Providence Bicycle and Pedestrian Advisory Commission

Staff Report: “Downtown Transit Connector” – Downtown, Upper South Providence - Wards 1, 11, and 12 (For Action)

Presented at October 18, 2017 BPAC meeting

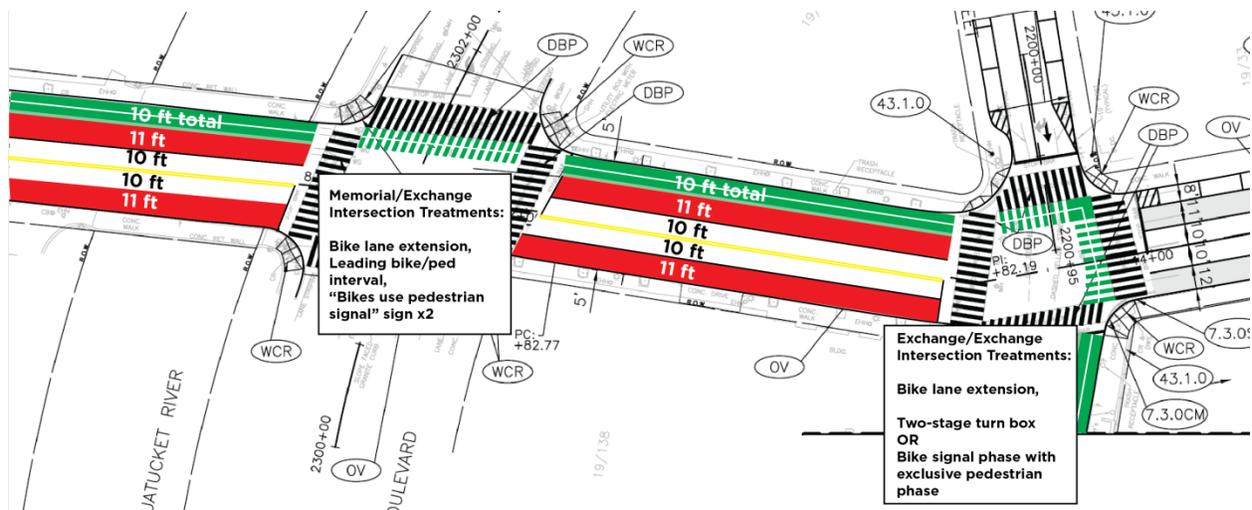
- **Relative safety of different bike lane options on Exchange Street between Exchange Terrace and Park Row West, as well as connection between Exchange Street bike lanes and proposed Exchange Terrace bike lane.**

- Reexamine the alternatives in “DAR 1 – Exchange St bike facilities”:
 - In “Consistency with Design Guidance,” the report equates the challenges with each option, even though lack of separation from traffic is widely shown to increase the stress level of a bicycle facility and contraflow bike traffic is an increasingly accepted standard, especially in the context of a two-way protected bike lane.

- In “Operational Impacts,” each option requires an increased total signal cycle length, so this should not be considered a specific problem with the protected bike lane in Option B (the two-way protected bike lane).

- In “Bicycle Accommodation,” the report equates the challenges with each option, even though lack of separation from traffic is widely shown to increase the stress level of a bicycle facility and the “unusual transition” at Exchange Terrace is easily designed based on engineering precedents such as bicycle signal phases, two-stage turn boxes, and protected intersections.

- Explore a bi-directional two-stage turn box at east corner of intersection to facilitate turns between two-way protected bike lanes on Exchange Street and Exchange Terrace.
- Explore inclusion of bicycle signal phase at the new traffic signal at Exchange Street and Exchange Terrace, potentially at the same time as an exclusive pedestrian phase.
